Service Information

Issued by
Nuffield Exports Limited

INDEX (Sheet 1)

STEERING ANGLES

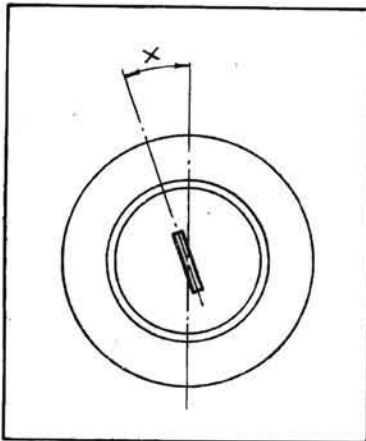
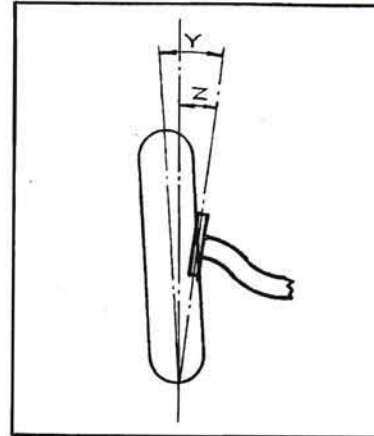
The following information has been compiled to assist service stations when checking the steering gear on the various models. It is not intended for use in repairing damaged steering parts and attention is drawn to Service Information Sheet No. 10 on this subject.

Model	Castor Angle " X "	Knuckle Angle " Y "	King Pin Angle " Z "
M	3° (B Nil—P 3°—S Nil)	9°	6½°
D, J, F	6° (B 3°—P Nil—S 3°)	9°	6½°
L	7° (B 3°—P 1°—S 3°)	9°	6½°
K, KN, TA, TB	6° (B 3°—P Nil—S 3°)	10½°	7½°
P, PB	8½° (B 3°—P 2½°—S 3°)	9°	6½°
N	8° (B 3°—P 2°—S 3°)	10½°	7½°
SA	4° (B Nil—P Nil—S 4°)	10°	8°
VA	4½° (B Nil—P 1½°—S 3°)	10°	8°
WA	4° (B Nil—P Nil—S 4°)	10°	8°
TC... ..	5½° (B 3°—P 2½°—S Nil)	10½°	7½°
Y	1° ± ½°	10°	10° 11½° on full bump or rebound

VIEW SHOWING SPEEDOMETER FLEXIBLE
CABLE RUN BETWEEN FOOT RAMP AND
CLUTCH HOUSING

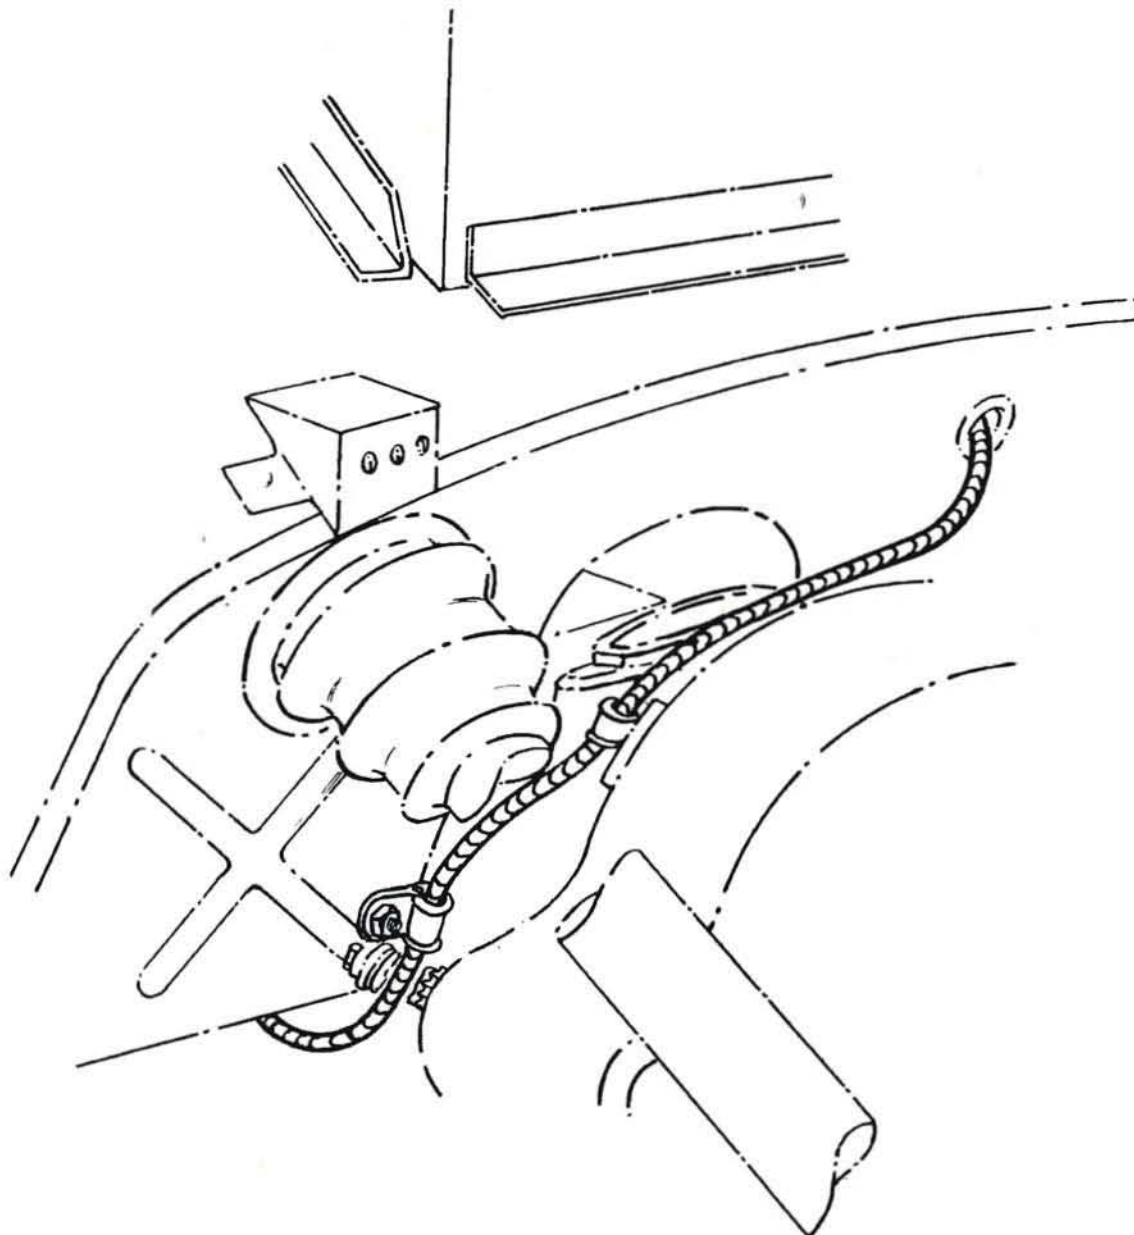
Complaints have been received of broken speedometer flexible cables, and oil finding its way up the cable and on to the numerals of the trip.

To obviate this, and commencing at Chassis No. TC.2196, a new cable, Pt. No. A.1270, Jaeger No. F.245, is being fitted. Cables incorporated on chassis prior to the one quoted may be changed for the later type if desired.

The run of the cable has also been modified, and from the drive it will now pass under the gearbox in a fair radius to clear the exhaust pipe and up the off-side, being clipped to the underside of the foot-ramp, and running over the clutch housing, clipped to the clutch housing bolt, and through existing hole and grommet, as shown in sketch overleaf. The clip on the clutch housing should be twisted to maintain the curve of the flex over the housing.

BRAKE MASTER CYLINDERS

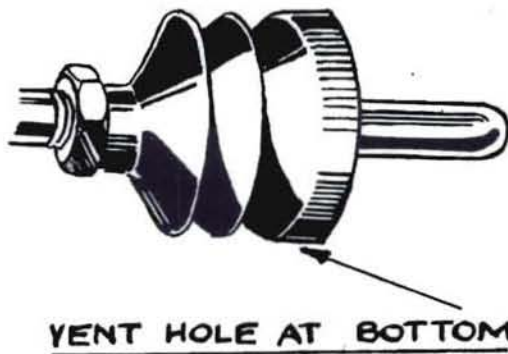
When assembling push rod to Lockheed brake master cylinder, care should be taken to see that the rubber boot is assembled with the vent hole at the bottom.

DISTRIBUTORS

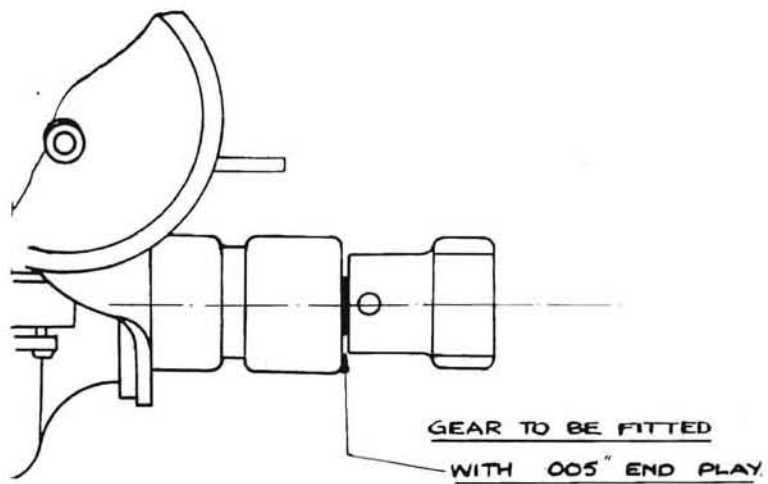
When fitting the gear to a distributor spindle, .005 in. end play should be left as shown in the sketch below.

FIG. 1.
ORIGINAL ONE-PIECE GASKET.

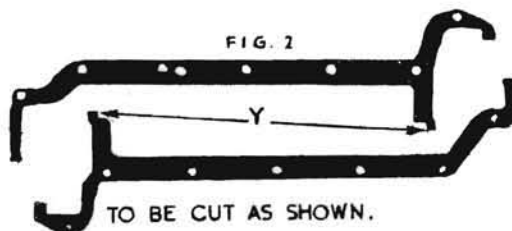
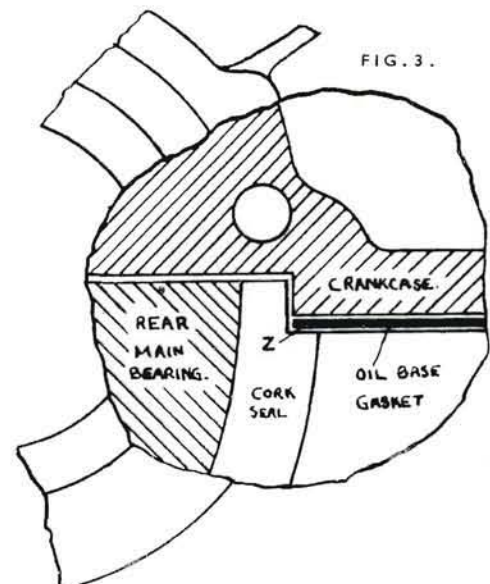
When refitting the oil base particular care is necessary to ensure that oiltight joints are made around the front and rear crankshaft bearings.

In the first place it is necessary to take great care in cutting the gasket at the points X in Fig. 1. It is essential that the full length of the tags (shown at Y, Fig. 2) should be preserved, and that these should be cut perfectly square.

This done, the gasket should be stuck to the face of the *crankcase* with jointing compound, care being taken to ensure that the tags (Y, Fig. 2) come level with the edge of the machined face of the crankcase at the point where it is cut away to admit the rear main bearing cap (see Fig. 3).

The cork seal may now be stuck with jointing compound into the recess in the rear main bearing cap, care being taken to insert the ends of the seal between the bearing cap and the crankcase, as shown in Fig. 3. It is essential that there should be a good joint between the ends of the cork seal and the oil base gasket (as at Z, Fig. 3).

Service Information Sheet No. 71**1½ LITRE GEARBOX****JUMPING OUT OF THIRD GEAR**

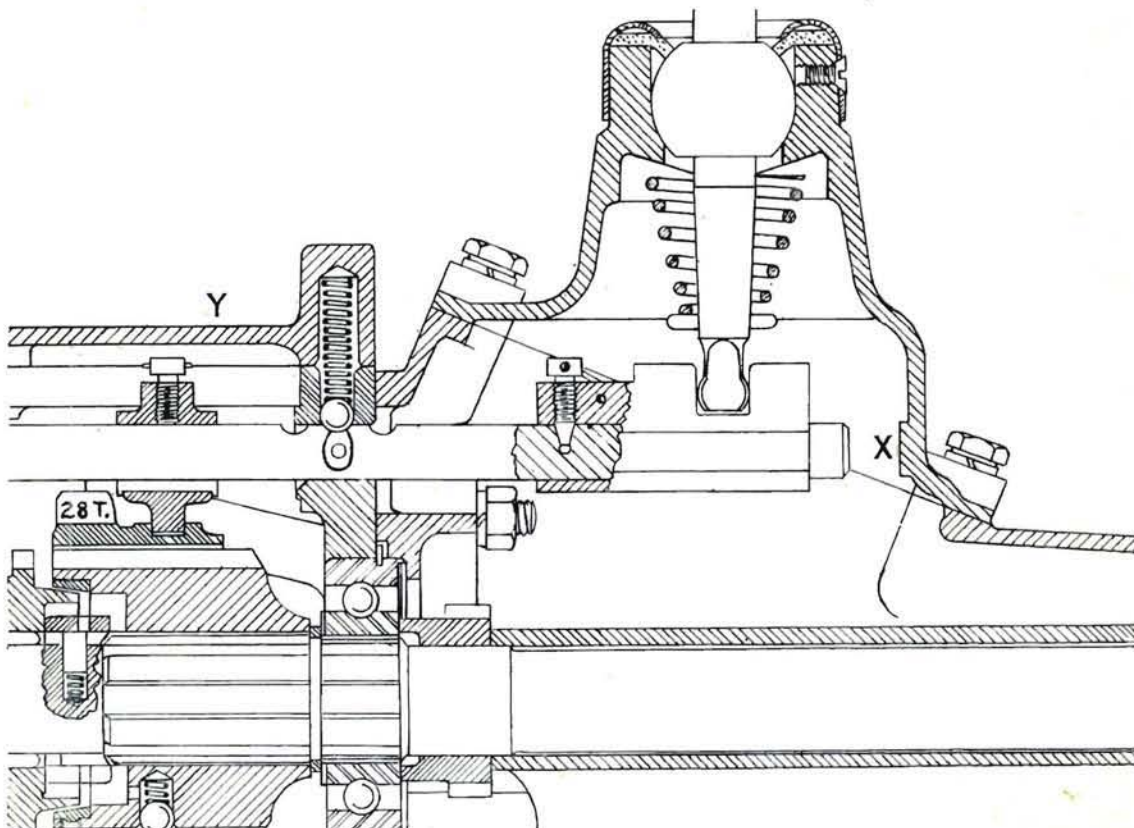
The stop for the third speed selector shaft is an abutment on the "cover for rear casing" on which the gear lever is mounted, marked X on the sketch below. Because this cover is mounted on an inclined face it is a matter of some difficulty to hold the limits for this stop, and it is possible for the third speed selector shaft to come up against its stop before the detent ball is fully seated in its groove. In these circumstances third speed will not always stay in mesh.

The remedy is to remove metal from the stop sufficient to allow the detent ball to seat correctly.

To do this the gearbox cover (marked Y in the sketch) should be removed, together with the third speed detent ball and spring. If the gear lever is now moved as far as it will go to the third speed position it will be possible to see, by looking down the detent ball hole, by how much the shaft stops short of the fully engaged position. This indicates the amount to be removed from the stop.

It is advisable to remove from the stop slightly more metal (about $\frac{1}{32}$ in.) than is necessary to permit full engagement. A condition can arise where the shaft just touches the stop in the normally engaged position and creates an annoying jangle, which is transmitted up the gear lever into the car.

Service Information Sheet No. 73**FRONT AXLE AND STEERING**

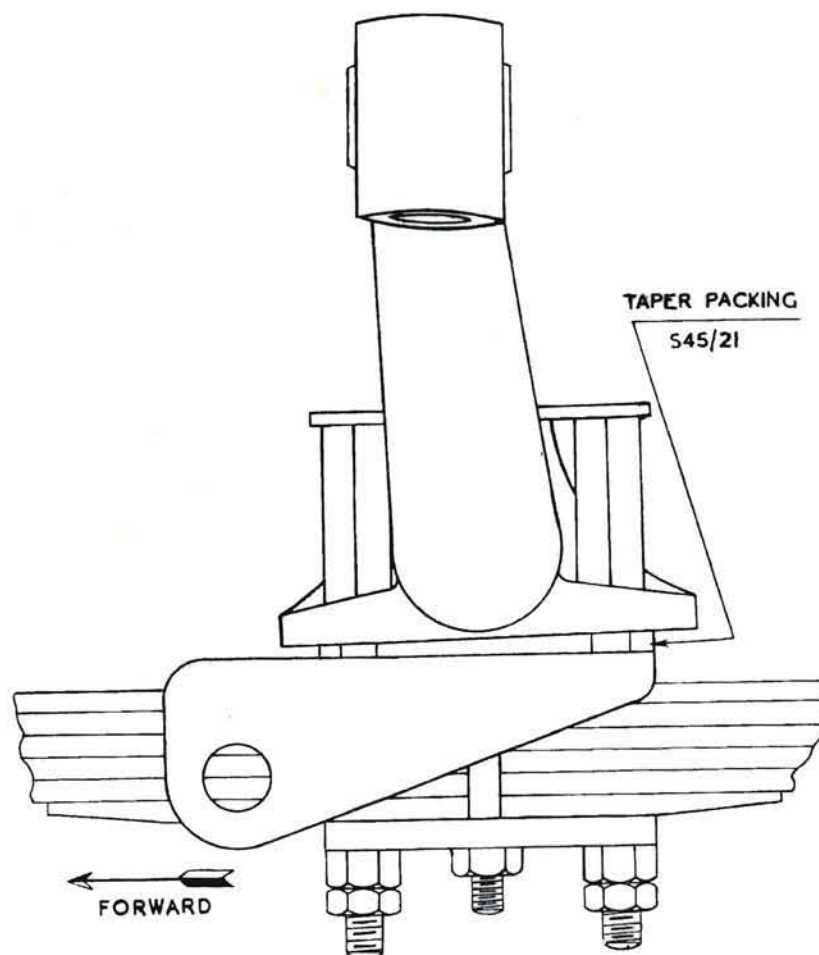
An improvement is effected by reducing the castor angle from 8° to $5\frac{1}{2}^{\circ}$.

Cars produced prior to Chassis No. TC4251 may have this modification incorporated by fitting a taper plate—Part No. S45/21.

The correct position for the taper plate to be fitted is immediately beneath the front axle pad, with the *thicker* portion at the *rear* as shown in the sketch below.

LATERAL CONTROL LINK BRACKET

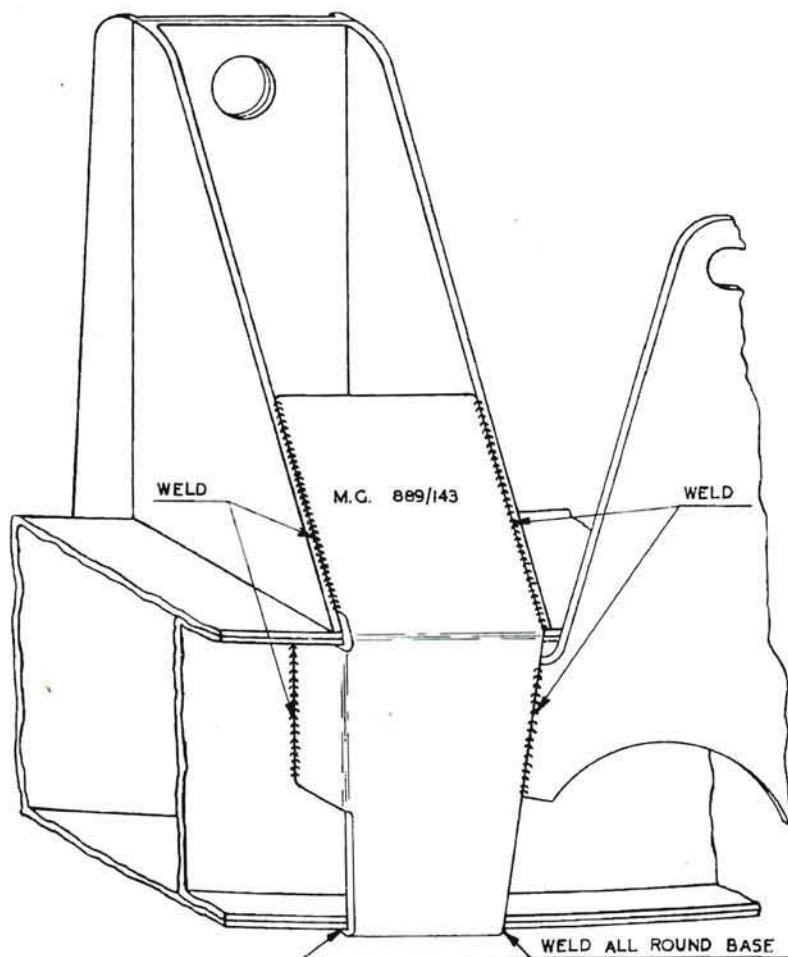
This component which is integral with the rear of the chassis frame has been reinforced on car production commencing at Chassis No. Y0541.

There is a possibility, on vehicles prior to this, that the bracket may tend to break away from the chassis frame.

If this condition arises the fractures should be repaired by gas welding, and a reinforcing plate, to Part No. MG889/143, welded on to the existing bracket.

The drawing below shows the welding seams for the attachment of the reinforcing plate.

HYDRAULIC PISTON DAMPER CARBURETTORS PREVENTS THE SUCTION PISTON RISING TOO RAPIDLY DURING SNAP ACCELERATION. THE HOLLOW PISTON ROD SHOULD BE FILLED TO WITHIN HALF AN INCH OF TOP OF ROD WITH N.O.L. "TWENTY" ENGINE OIL - AFTER THE TOP BRASS CAP HAS BEEN UNSCREWED.

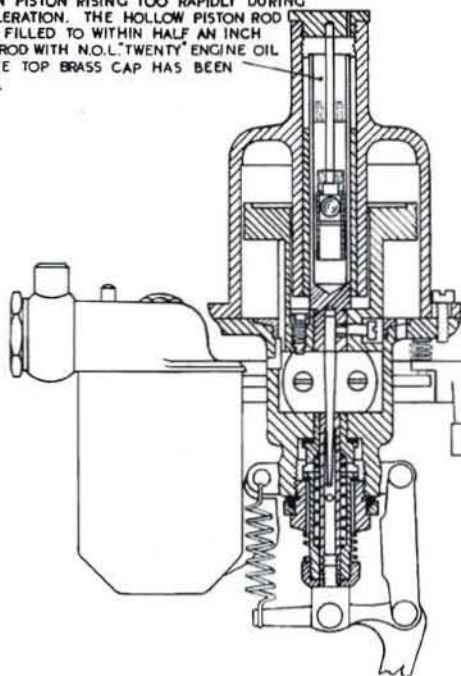
As from Car No. TC.3856, carburettors are fitted with hydraulic dampers, Part No. A1326/3, which are incorporated with brass suction pistons, Part No. A1311/3. E.S. needles are retained as standard.

The hydraulic suction piston damper is a device located in the hollow piston rod and attached to the oil cap nut. It consists of a plunger with a one-way valve, and its function is to give a slightly enriched mixture by preventing the piston from rising unduly quickly on acceleration. Its effect is therefore helpful in cases where hesitation in acceleration from the lower speeds is encountered.

It should be noted that the hydraulic damper fitted to the TC Midget differs from that fitted to the 1½ litre. The ball valve of the former has a travel .040 in. greater than that of the latter, and this can be seen by the position of the ball retaining pin in the piston. In order to distinguish the TC damper from other dampers in stock, the TC damper is copper-plated, while the others are left with their brass finish.

A section drawing of the carburettor showing the damper is given below.

REAR ENGINE MOUNTING

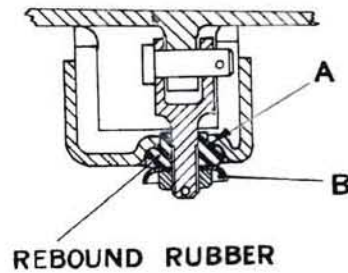
In order to prevent the rebound rubber (Part No. S75/52) from being cut by the rear engine mounting bracket, and also by the edges of the bottom washer, the hole in the bracket should be given $\frac{1}{8}$ in. radius where it is in contact with the rubber. (See A on the drawing.)

A new cup-shaped washer, Part No. S44/203, should be fitted to replace the flat one (B).

This modification has been included on cars produced from Chassis No. Y.0989.

EXCESSIVE OIL CONSUMPTION

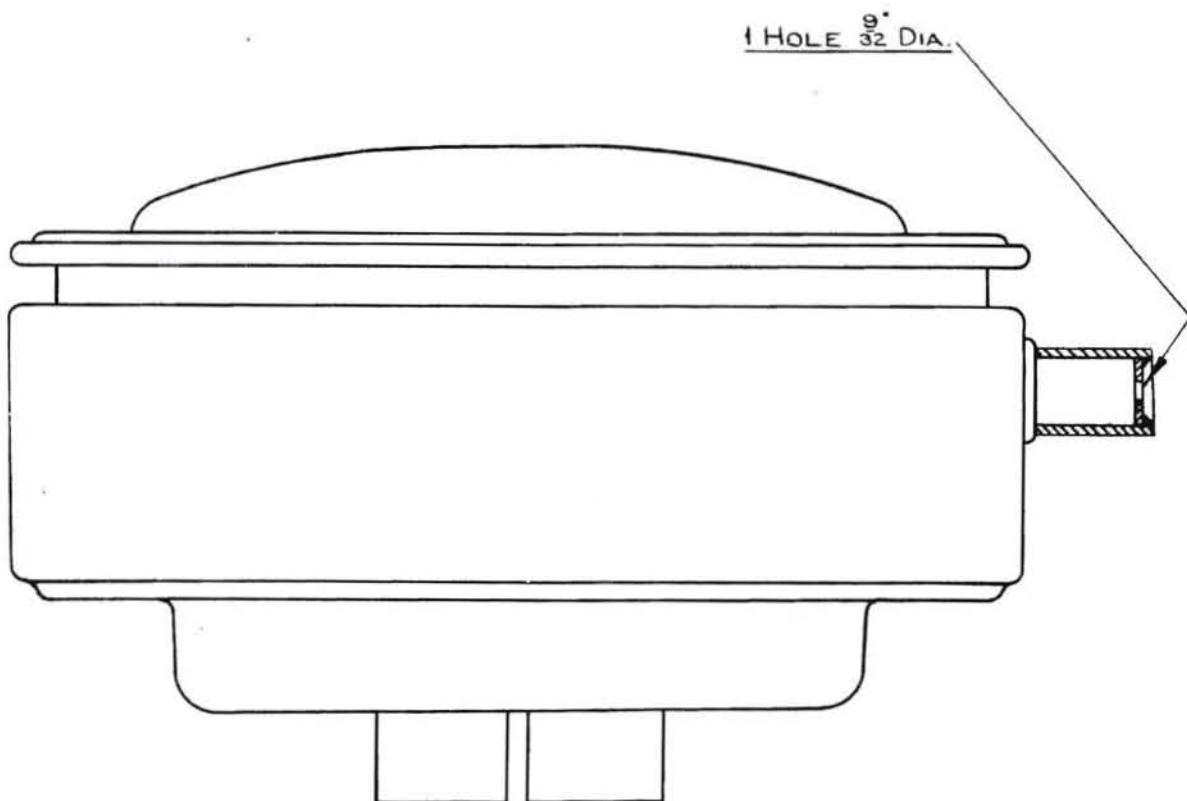
Some early cars of the "TD" Series have been observed to have a heavy oil consumption.

In some cases this has been found to be due to oil passing from the valve cover into the air cleaner and being consumed in the engine.

This can be prevented by inserting a restrictor or washer in the air cleaner engine breather pipe as indicated in the sketch below.

Sectional view of the gearbox

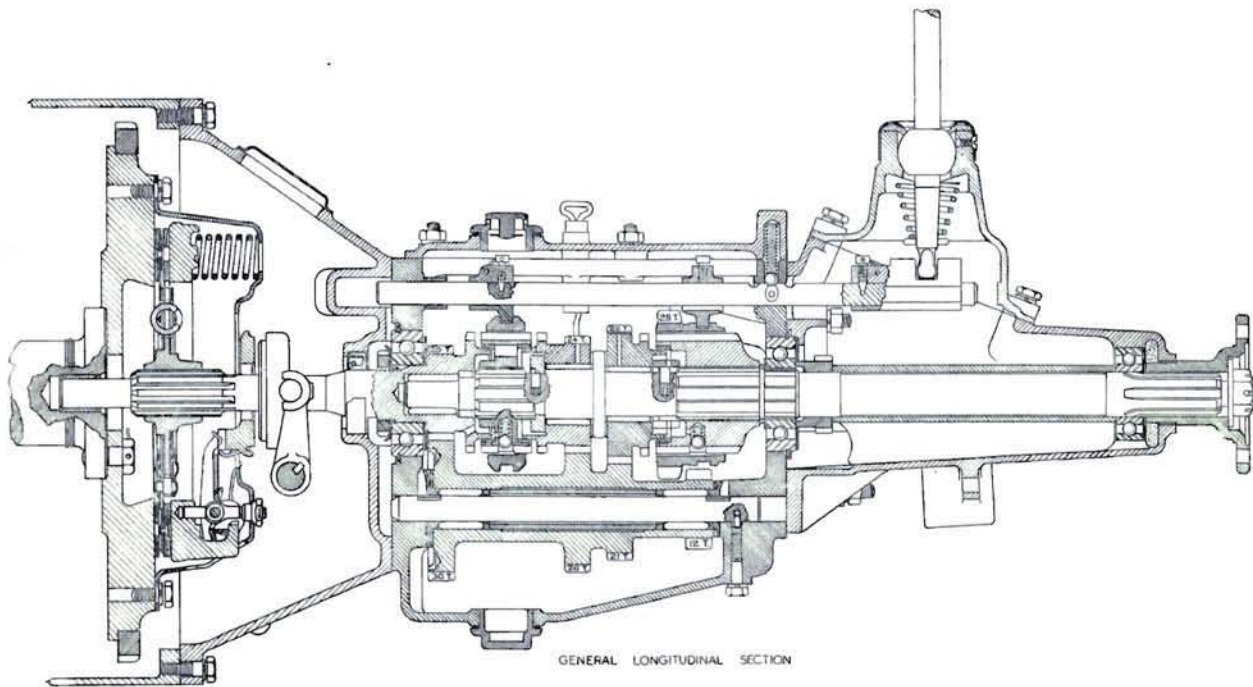
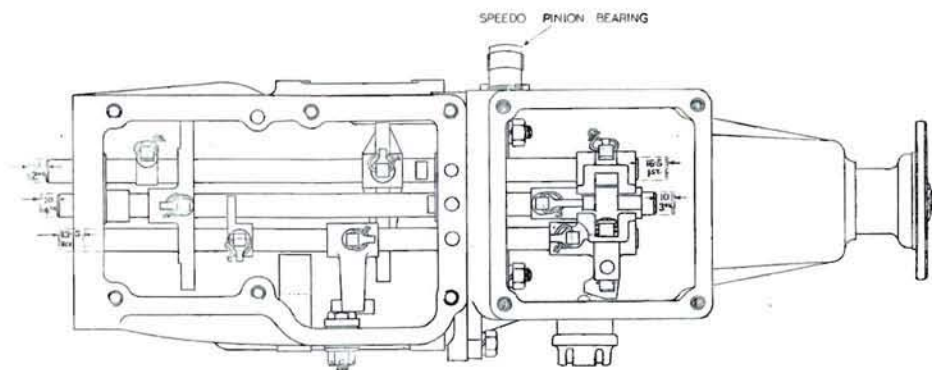
Cases have been encountered where the synchromesh hub balls have dropped out of their cage into the bottom of the gearbox, necessitating the dismantling and reassembly of the complete gearbox.

To obviate this, extreme care must be taken when removing and refitting the gear change lever not to withdraw the third speed gear selector shaft past the first stop, as this will cause the two components of the synchromesh mechanism to slide apart, releasing the balls and springs, which will drop into the box.

The third speed selector shaft is provided with two stops—one of the spring-loaded ball type, the other consisting of a boss on the inside face of the gear-lever housing. When the housing is removed there is no longer a rear stop to arrest the movement of the third speed selector shaft, which is liable to be withdrawn beyond its normal travel.

Reference to the accompanying illustration of the gearbox will make this clear.

On later models a longer selector shaft is fitted which has a retaining circlip at its forward end to prevent it from being withdrawn too far.

GREASE LEAKAGE FROM FRONT HUBS

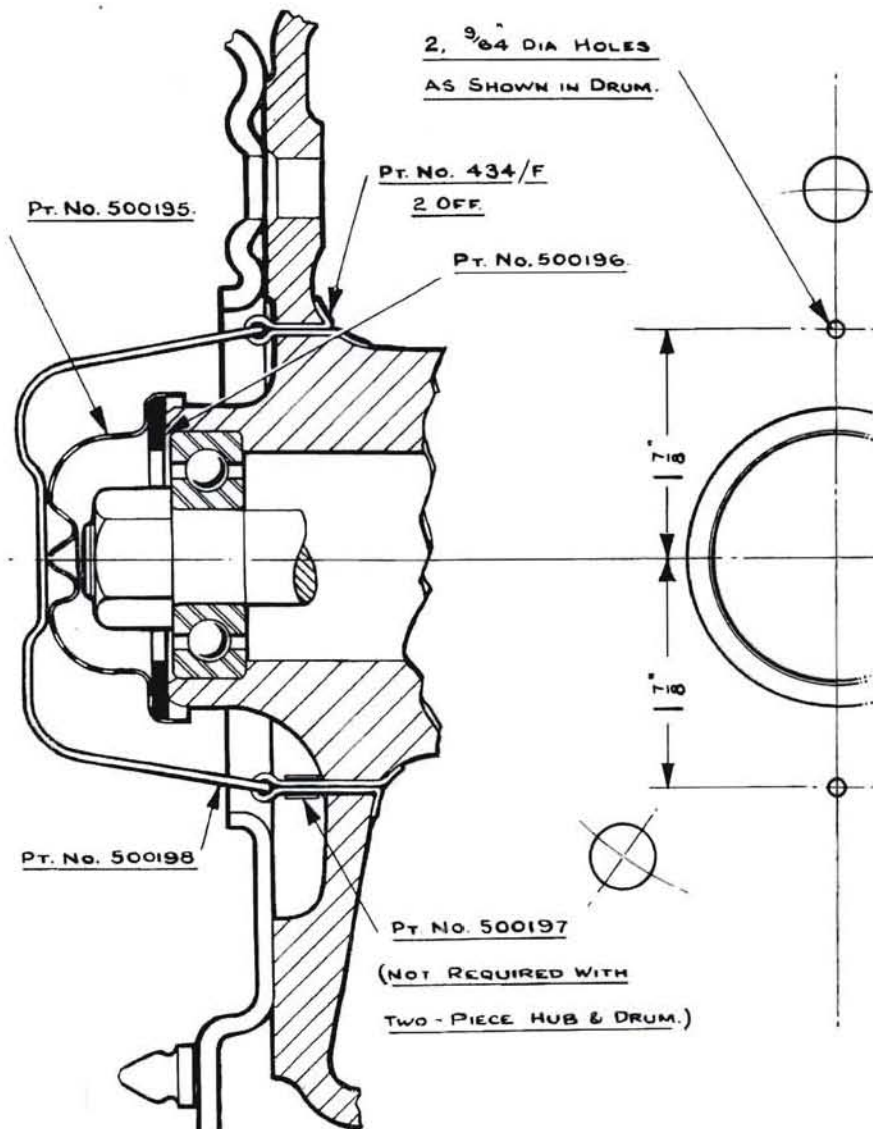
The front hubs have been subject to grease leakage from the outside felt, and production cars in future will have a grease cap fitted to the hub end, which will entail a longer hub, etc.

For existing cars without grease caps a special service cap is available, which is retained in position by a spring and provided with a rubber sealing gasket, as indicated in the illustration below.
